CITY OF DOVER

PLANNING TECHNICAL REVIEW COMMITTEE –AGENDA

RE: "Settlement on 6th"
Settlement on 6th LLC
Sixth Street
Transfer of Development Rights Subdivision
Map B, Lot 5

On behalf of Settlement on 6th LLC, Berry Surveying and Engineering (BS&E) submits to TRC a proposed TDR subdivision off Sixth Street. The plans and design have been revised based on comments made by the first TRC on August 12, 2021. Our responses are in **bold**.

NEIGHBORHOOD PLAN
LAND OF
SETTLEMENT ON 6TH, LLC
SIXTH STREET
DOVER, N.H.
TAX MAP B, LOT 5

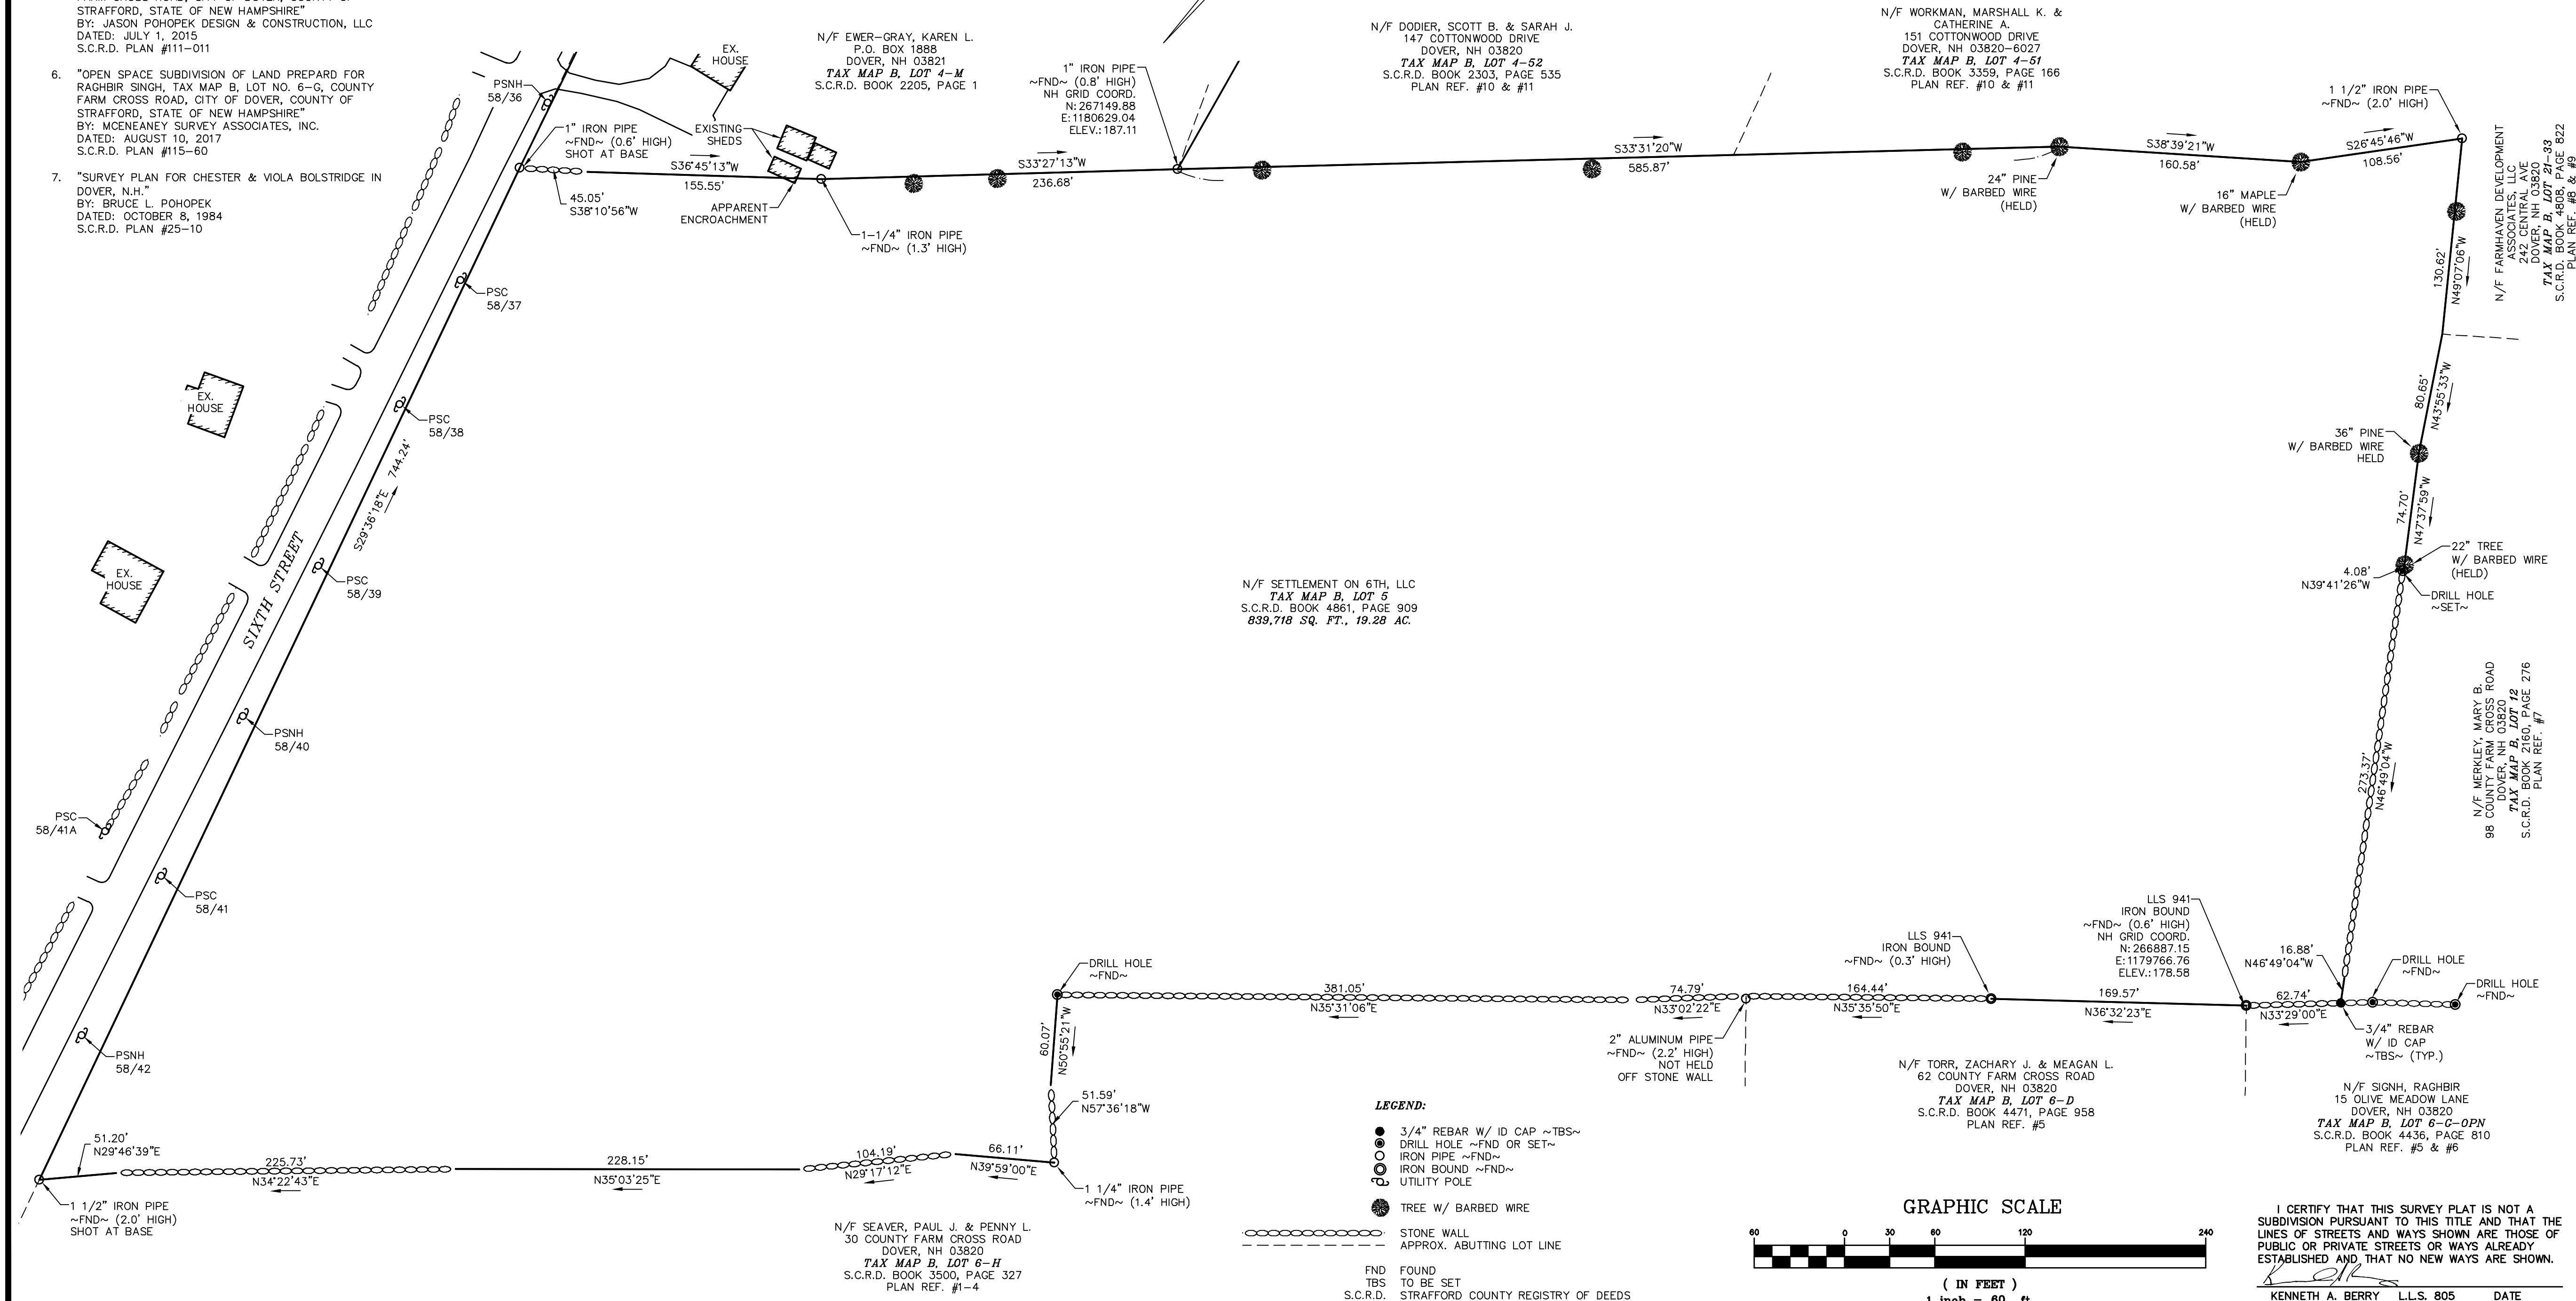
- Remove shed encroachment before plans are signed
Applicant if filing for a lot line revision with Lot 4-M to remove the encroachment.
- Clearer aerial on sheet 1 possible?
A clearer aerial has been provided on sheet 1.

GRADING PLAN & PROFILE WILDCAT DRIVE 0+00 - 5+50
LAND OF
SETTLEMENT ON 6TH, LLC
SIXTH STREET
DOVER, N.H.
TAX MAP B, LOT 5

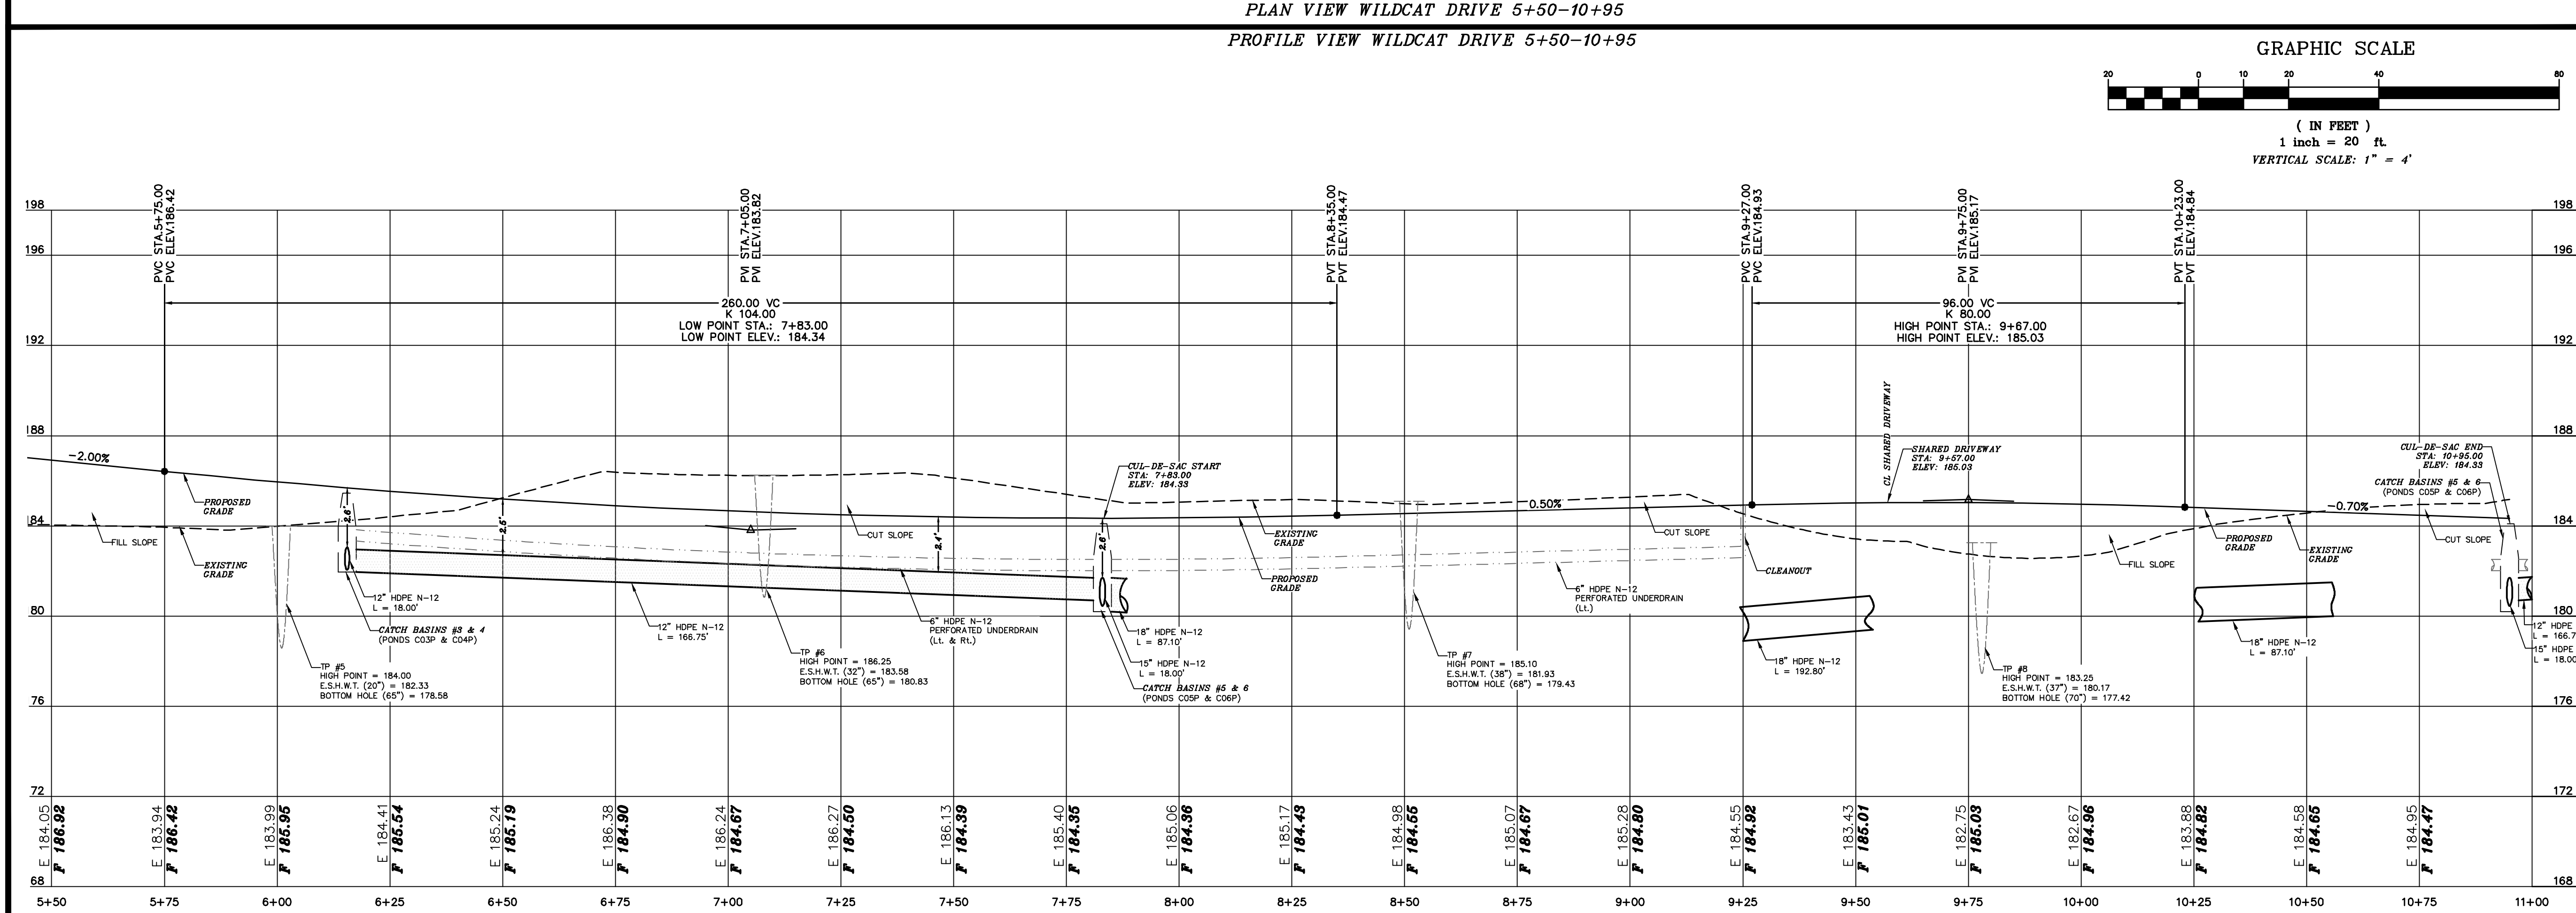
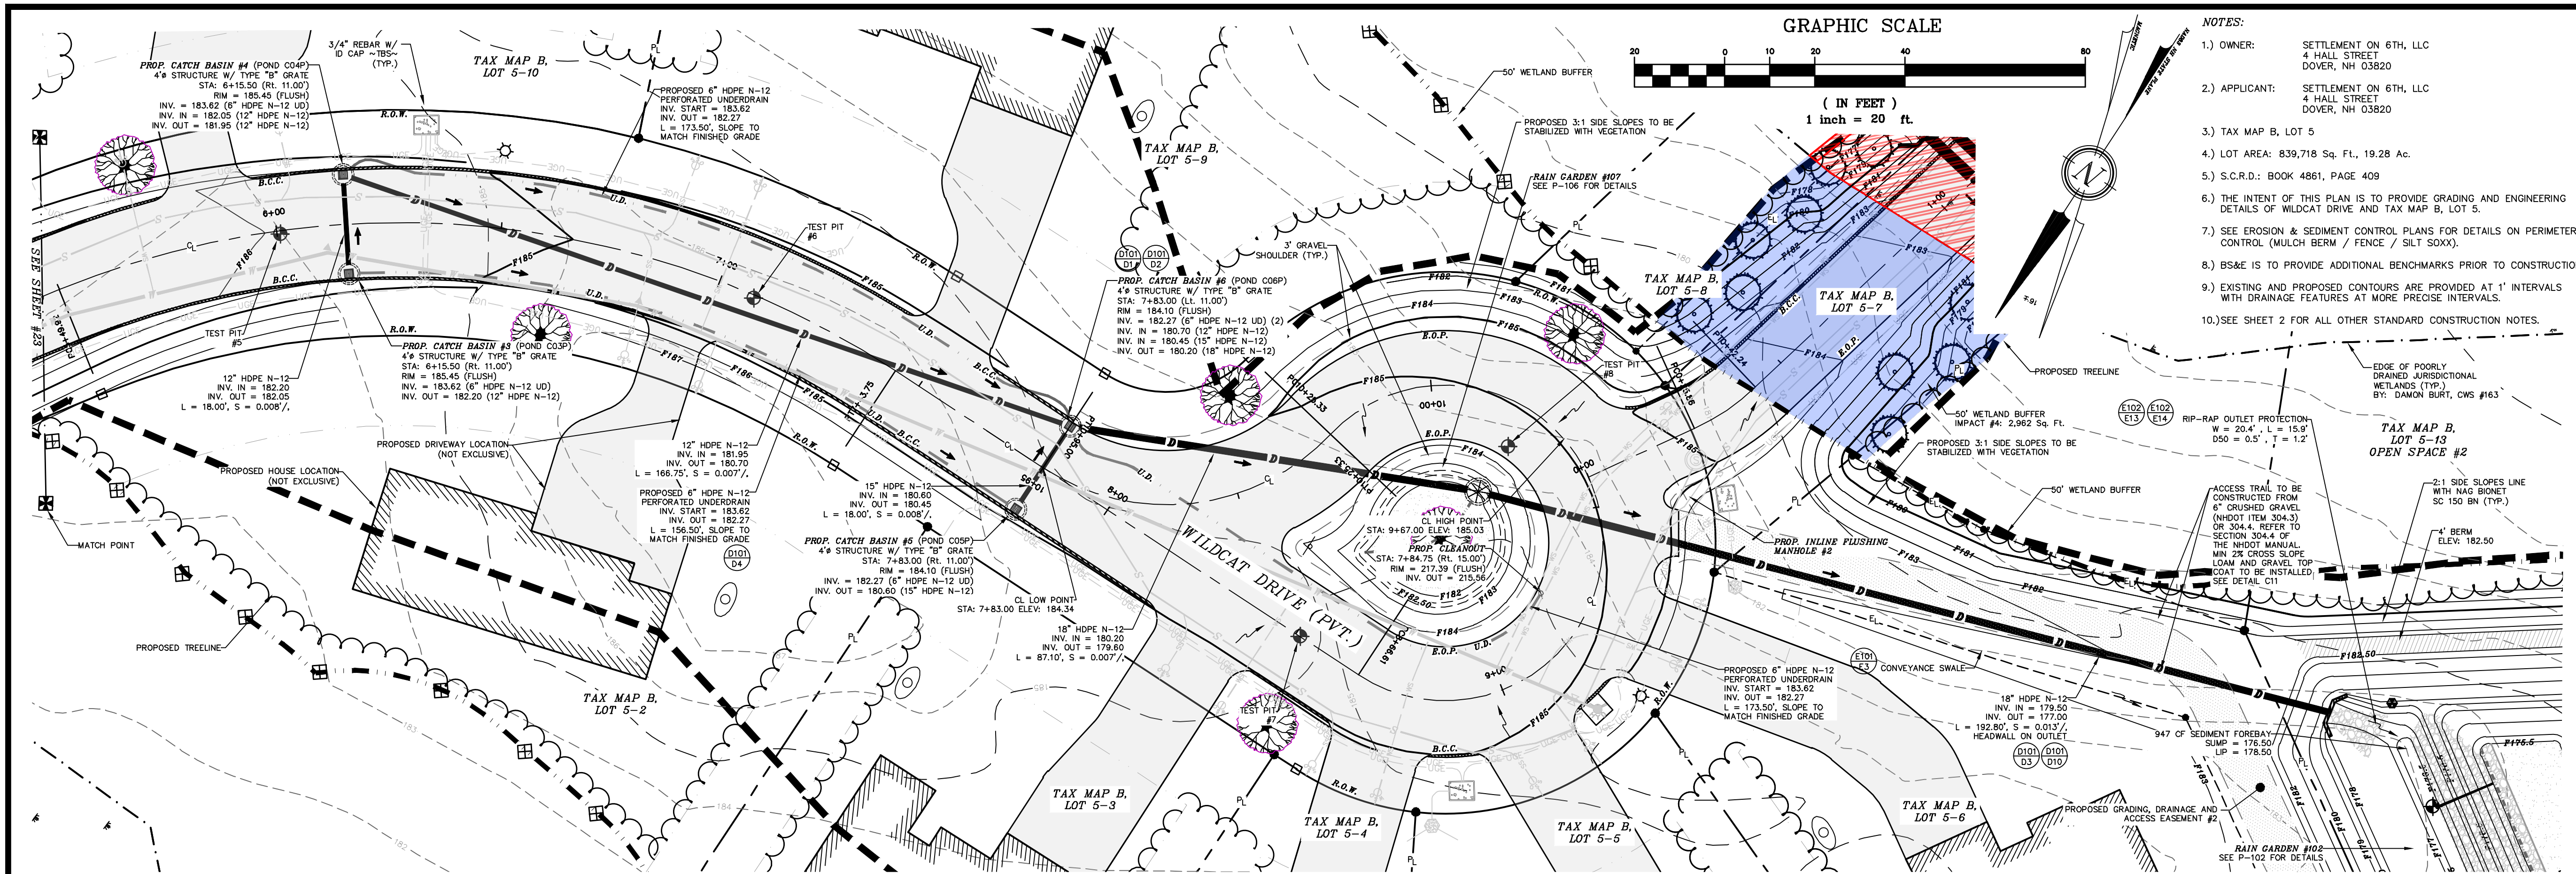
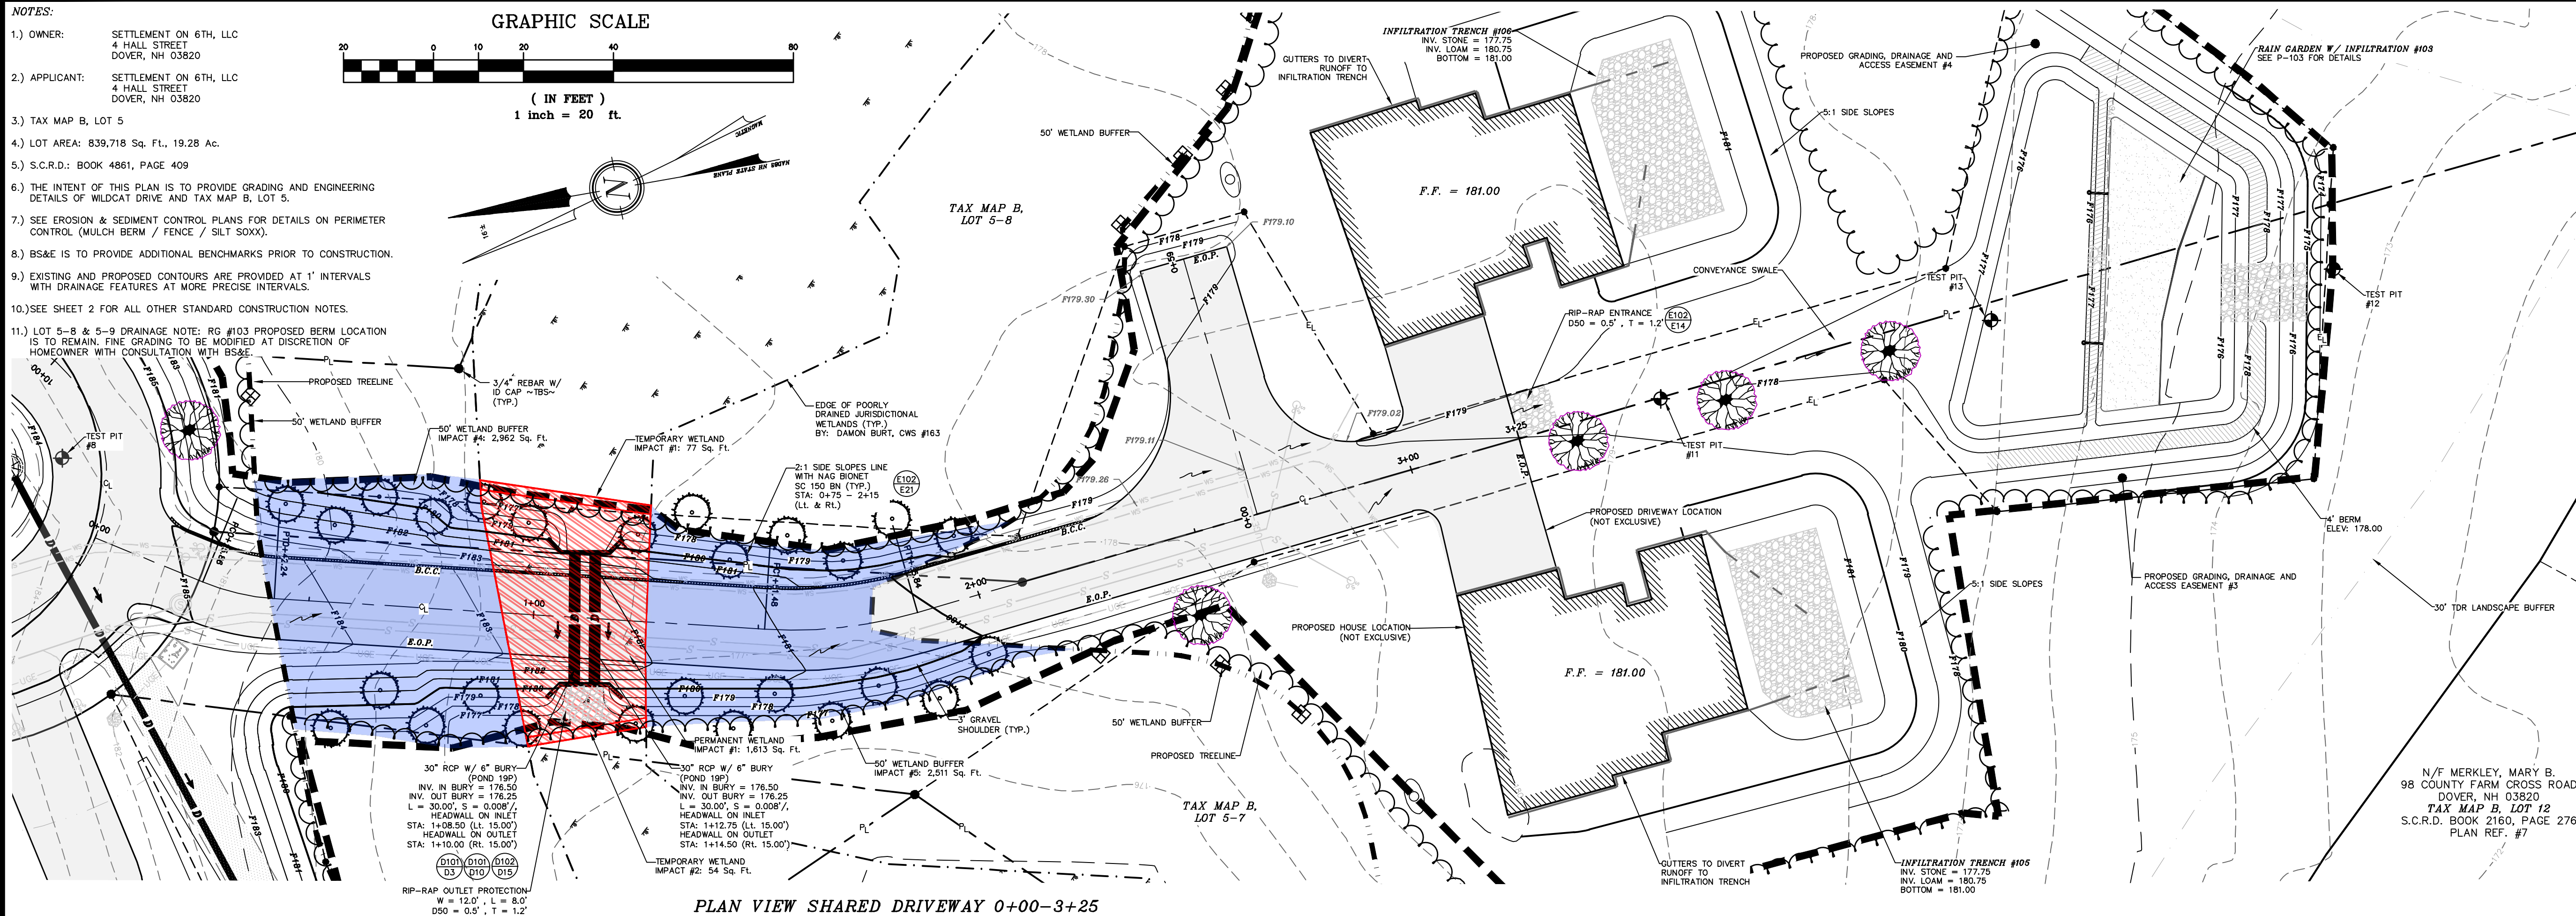
- Investigate gravity sewer to the RR easement or Cottonwood
The contractor will investigate the sewer prior to construction.
- Move no outlet sign closer to the entrance.
Outlet sign has been moved closer to the entrance, to station 0+60
- Check the invert grades on cb1 and 2. They are the same
The inverts of cb1 and cb2 are correct.
- Suggest adding another cb at 7+10 to realign pipe to give more room for other utilities
The utilities have been revised to allow for at least 5' of separation to the drain line at station 7+10.
- Move the water into the row around sta 700
Water line has been moved into the roadway at station 7+00.
